Docket No. 040-08980
Control No. 127200

License No. SMB-1541

Heritage Minerals Inc.'s (HMI's) Plan for the Decommissioning and Decontamination (D&D) of the Site Subject to NRC License #SMB-1541

RESPONSE TO NRC'S AND NJDEP'S COMMENTS ON HMI'S FSPP

FIGURE 2

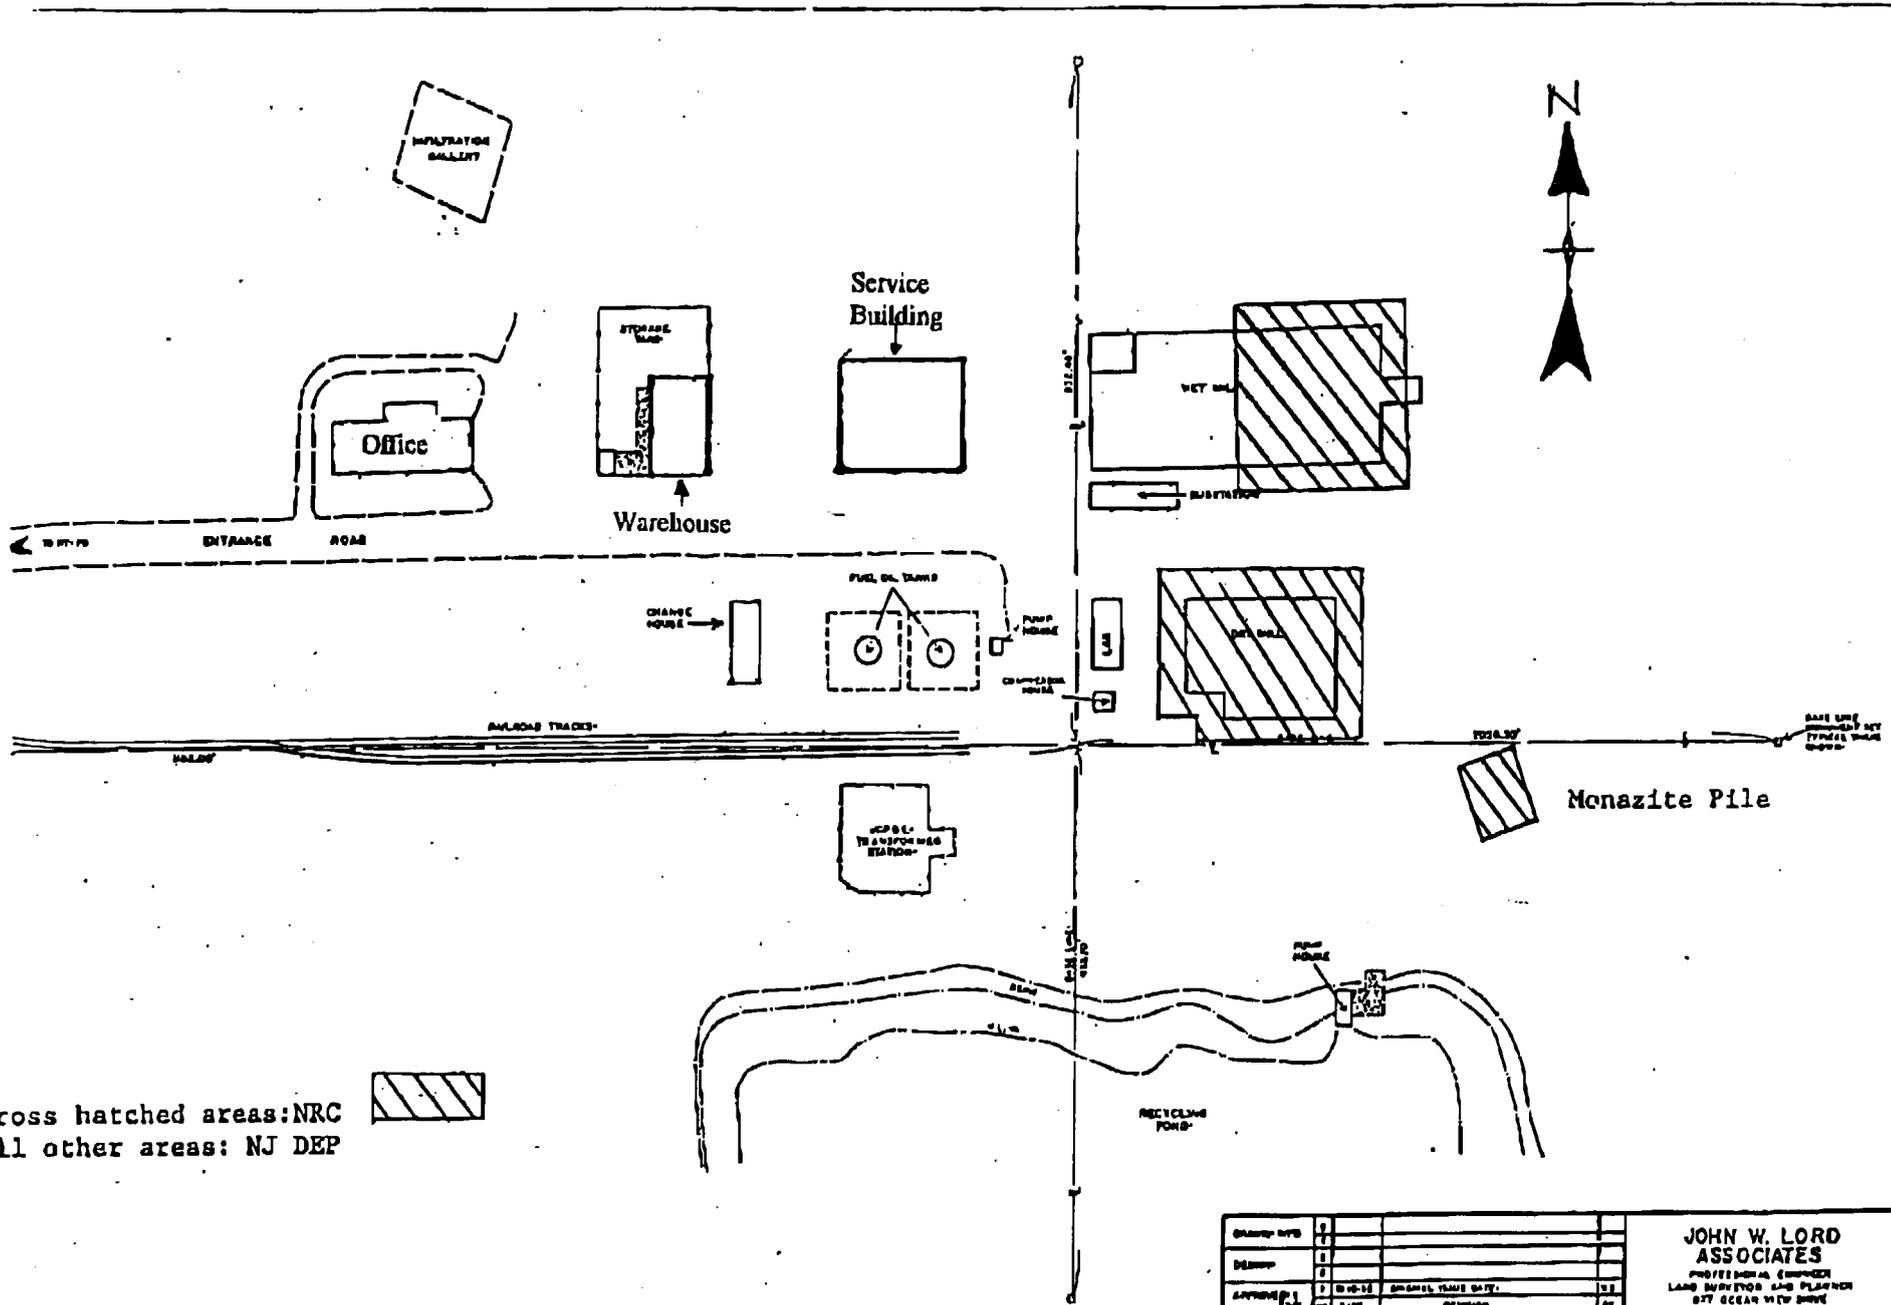
4. **Comment:** Figure 2 has no indication of north.

Response: A copy of a revised Figure 2 from the RSI FSSP showing an N arrow is attached. Also, please note that the hatching indicating the extent of the NRC areas of interest has been removed from the service building, warehouse, change house and office. The legend "*all other areas NJDEP*" was not clearly defined and the scale being incorrect were removed.
